Memorandum

Project: Lot 8, Wesbrook Village

The following changes have been made to the landscape design since drawings were issued for DP in May, 2018.

1 TREE RETENTION AND REMOVAL PLAN

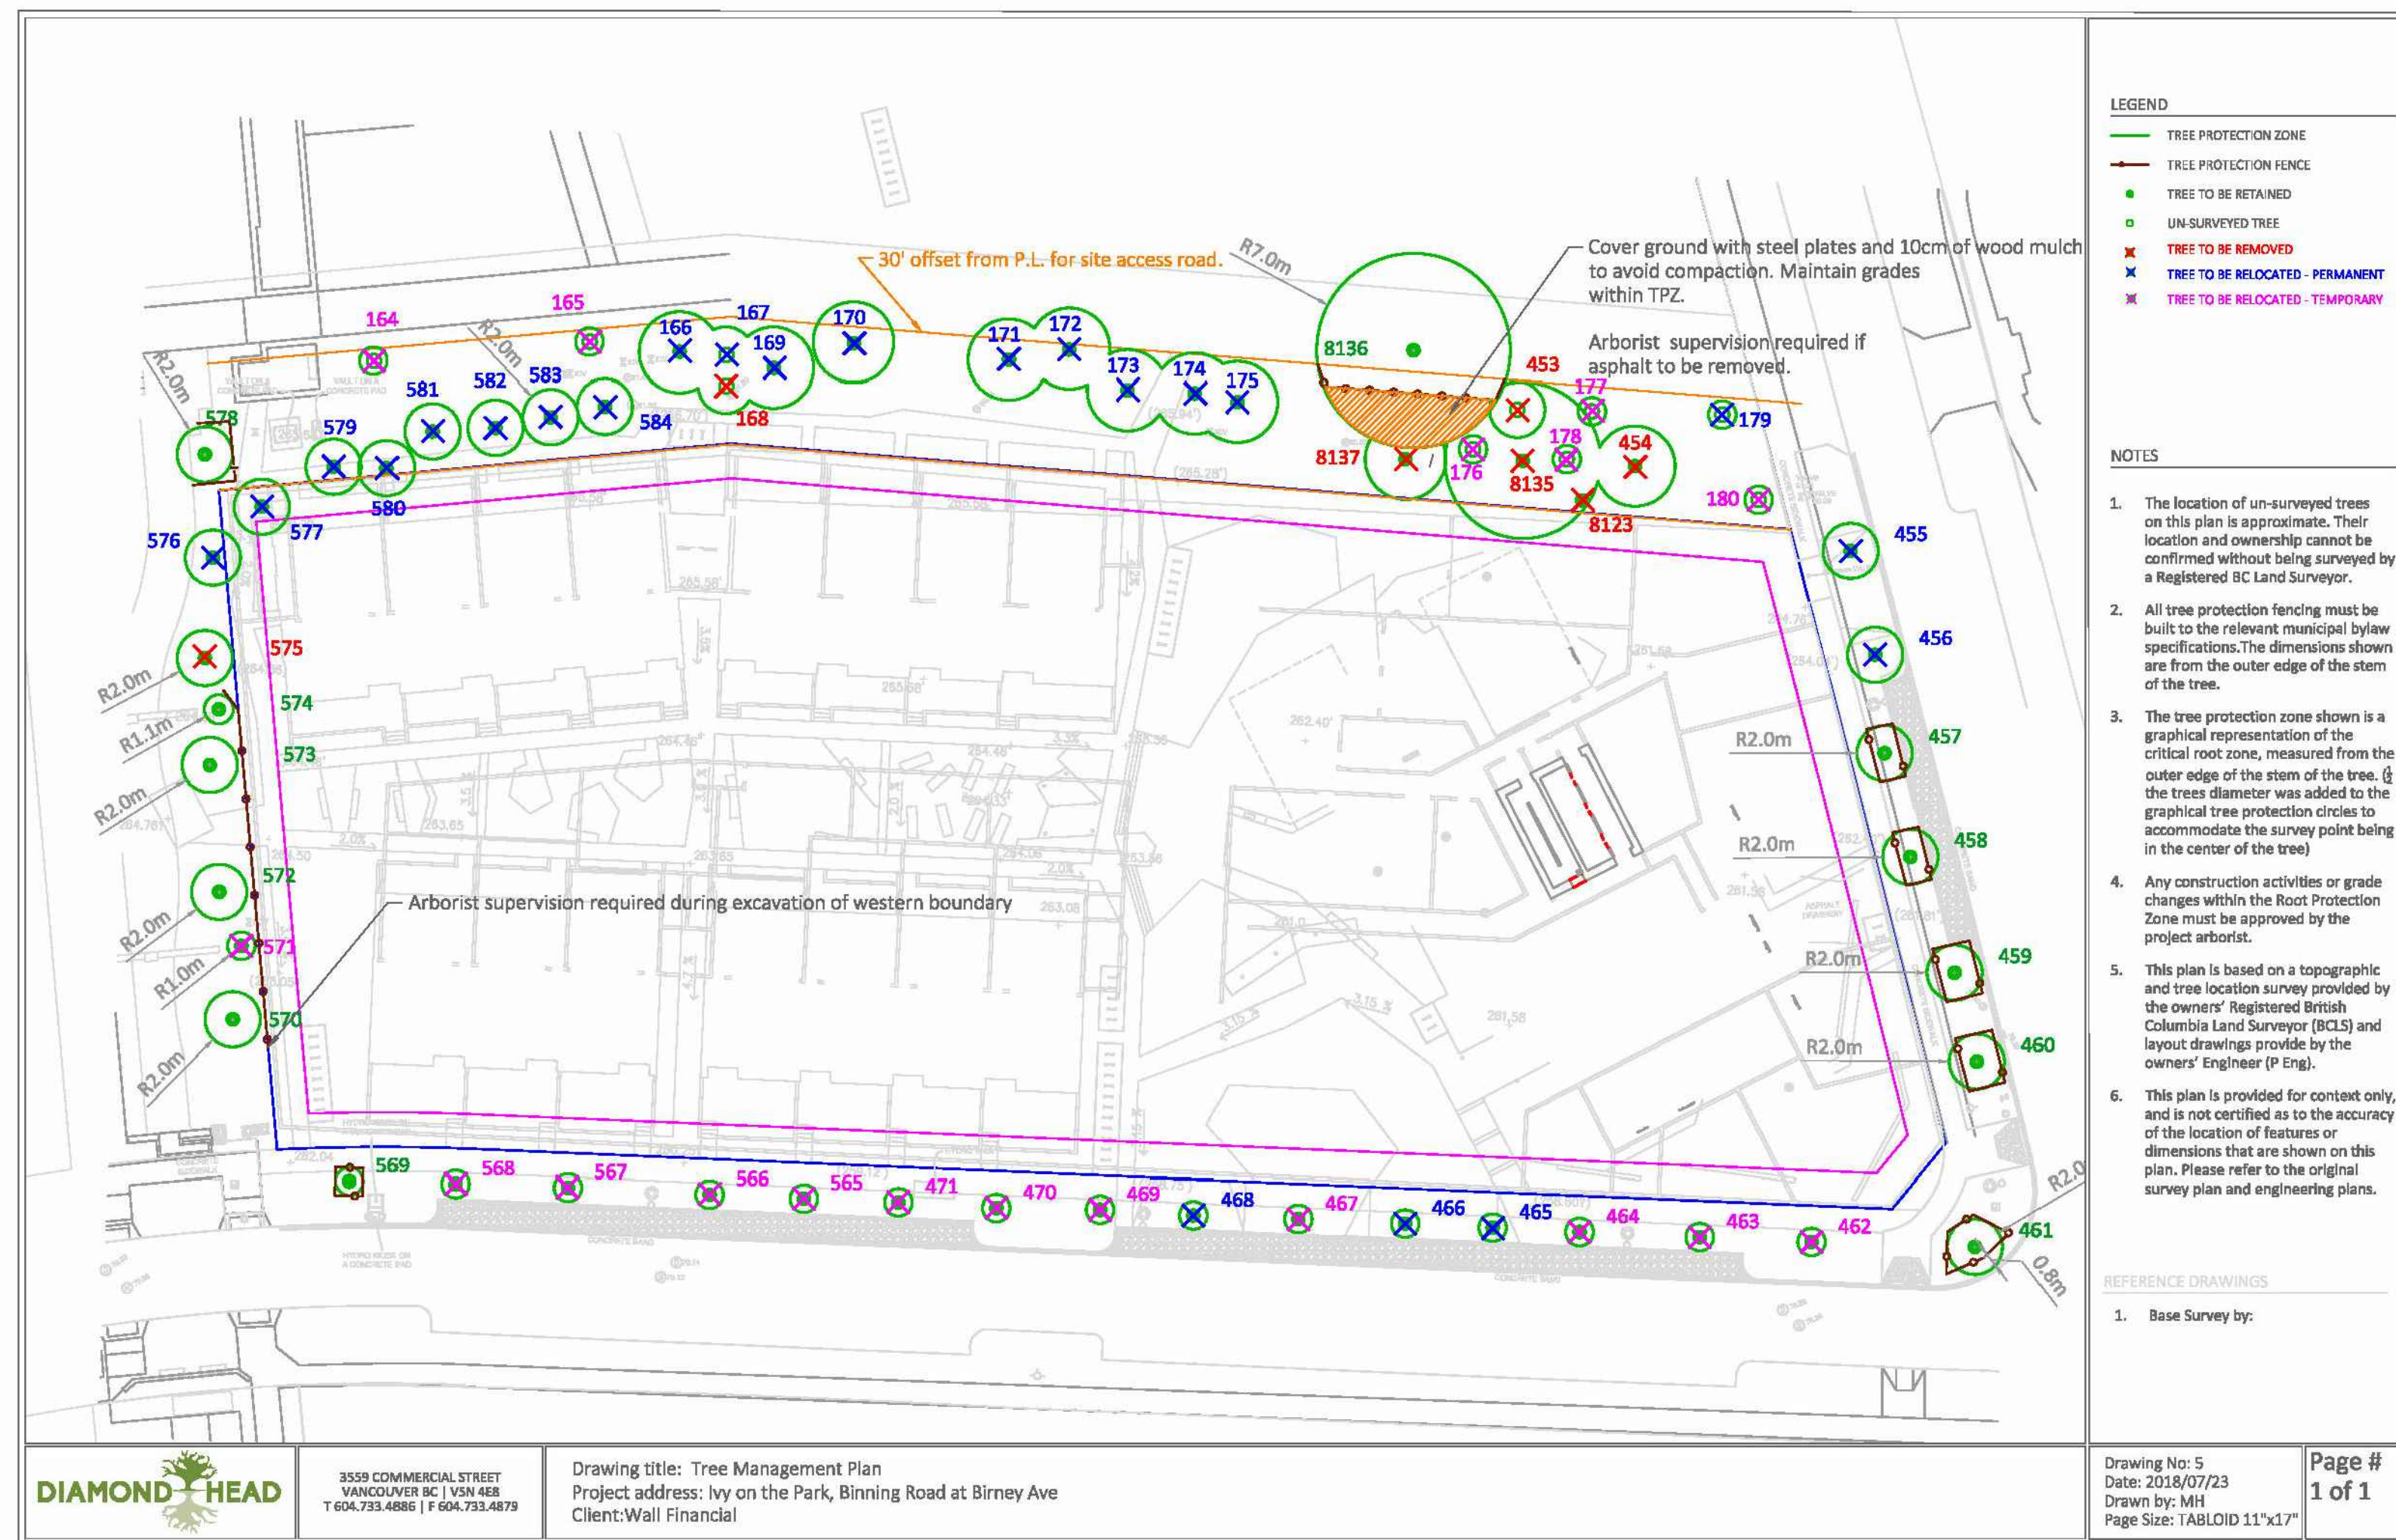
1. The entrance patio to the midrise building was simplified due to new grading information for the existing grades.
2. One additional bike rack was added to the walkway between townhouses.
3. Two additional bike racks were added to the meadow walk. A mechanical vent was added to the planting area.
4. The pavilion design was developed – see details.
5. The existing trees to be removed has been changed due to the need for a construction access route within Village Lane – See arborists report.
6. Bollards added to courtyard pathways, see lighting plan.
